WATER PERMIT NO. 6769-3

K Lazy K Ranch Dam Reconstruction NE1/4 Sec 20, T109N, R71W, Hyde Co.

**RECOMMENDATION OF CHIEF ENGINEER FOR WATER PERMIT
APPLICATION NO. 6769-3, K Lazy K Ranch**

REPORT ON
WATER PERMIT APPLICATION No. 6769-3
K Lazy K Ranch
December 15, 2006

Water Permit Application No. 6764-3
K Lazy K Ranch

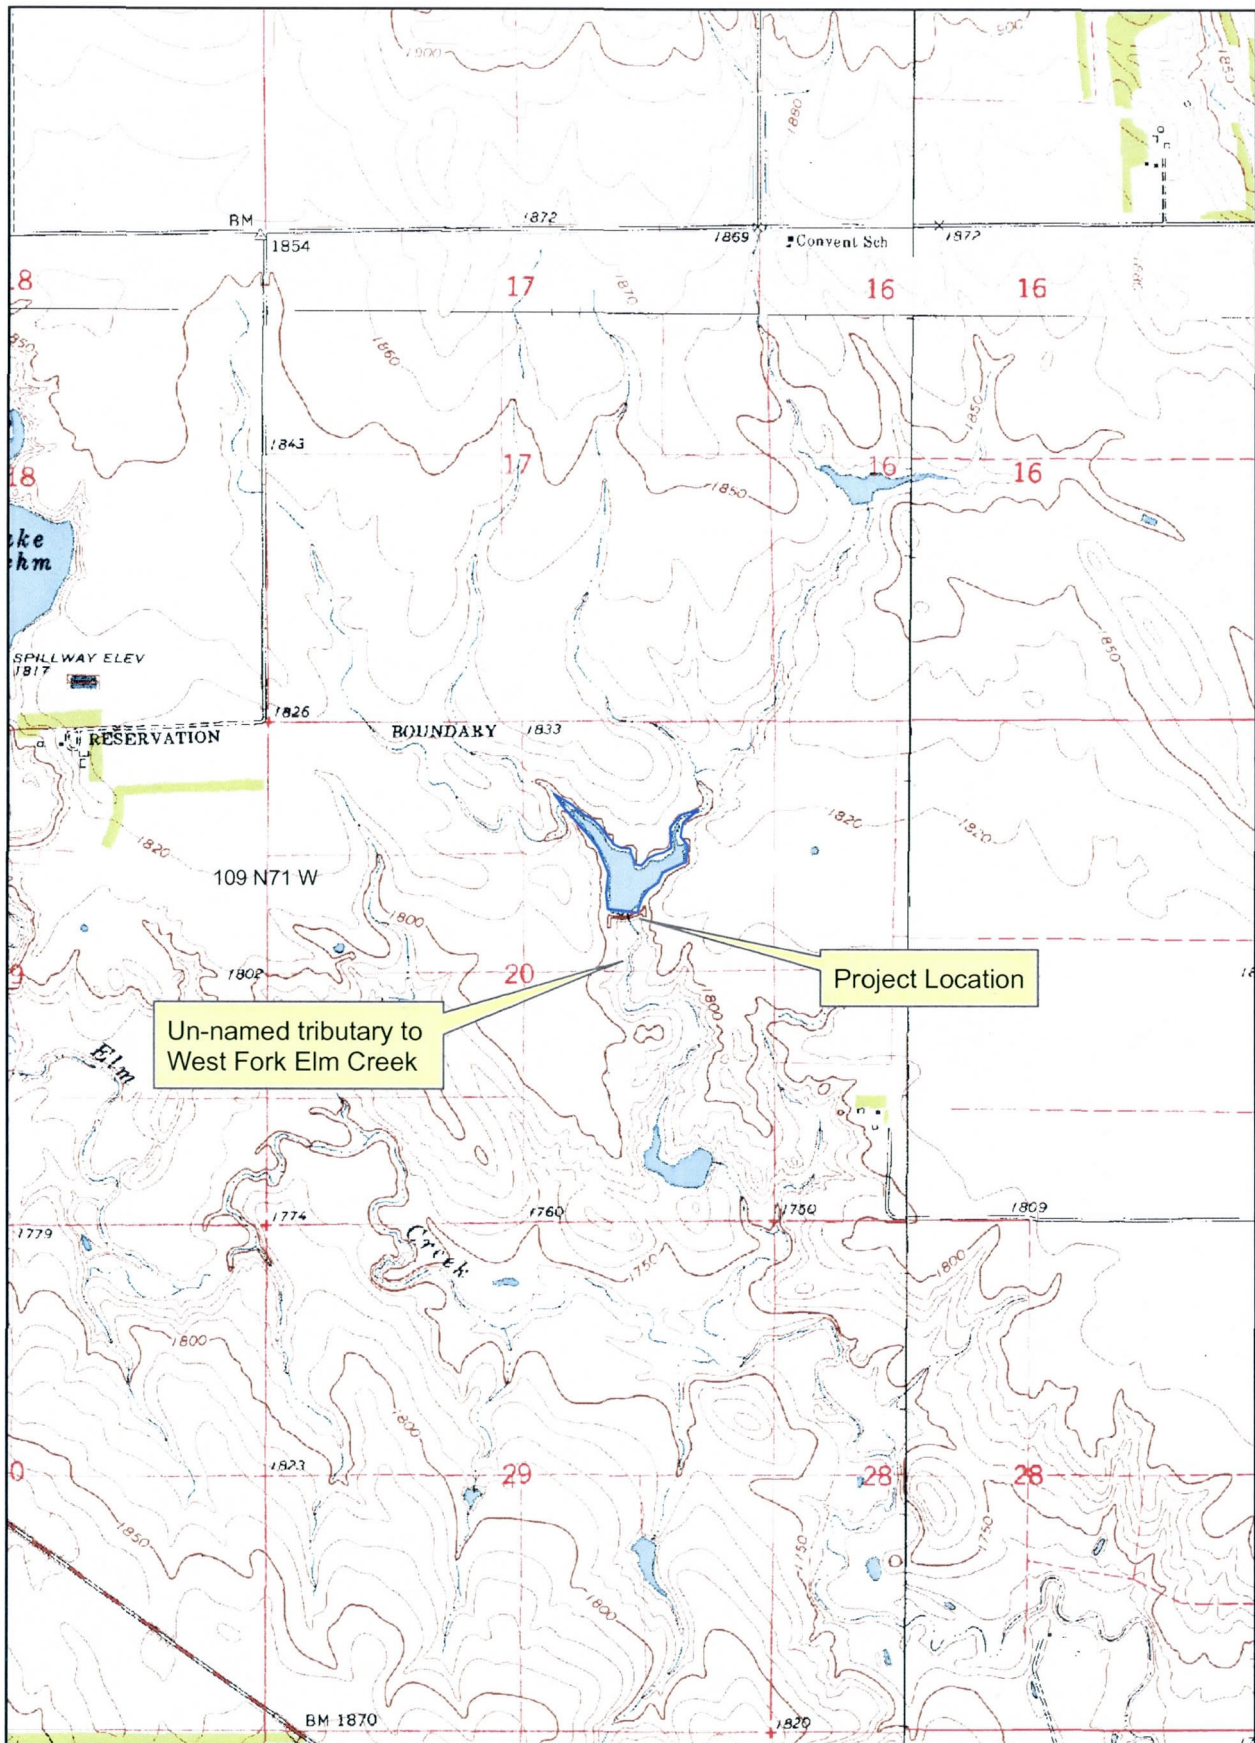
Top of Dam Elev. - 101 }
 2nd Spillway Elev. - 98 }
 P. Spillway Elev. - 96 } Ht = 14 ft.
 Dis Emb Toe Elev. - 87 } Cont. 3-Low Hazard Dam

Normal Storage Capacity - 45.5 Ac-Ft
 Int Storage Capacity - 70
 Max. Storage Capacity - 111

Int Capacity x Eff Ht. = $70 \times 11 = 770 < 3000 \therefore$ 25 yr
Minimum Spillway Design

From USGS WRI 98-4055 "Tech. for Est Peak Flows... in SD"
 DA = 2365 ac. = 3.70 mi.²
 Region B PIF = 0.85

$$= \underline{282 \text{ cfs}}$$

$$= \underline{552 \text{ cfs}}$$

$$= \underline{625 \text{ cfs}} \quad H = 3$$

1. Topo Map - OK
2. Dam Axis Profile - OK
3. Dam Max X-Sec. - OK
4. Area Capacity - OK
5. Outlet Details - OK
6. Spillway Rating - OK
7. Spillway Details - OK
8. Specs - std. NRCS - OK
9. EPP - Cat. 3 N/A - OK

$$0.13 \times 2365^{1/2} = \underline{25.62 \text{ Ac-Ft}}$$

$$0.36 \times 2365^{1/2} = \underline{71 \text{ Ac-Ft}}$$

$$1.8 \times 2365^{1/2} = \underline{355 \text{ Ac-Ft}}$$
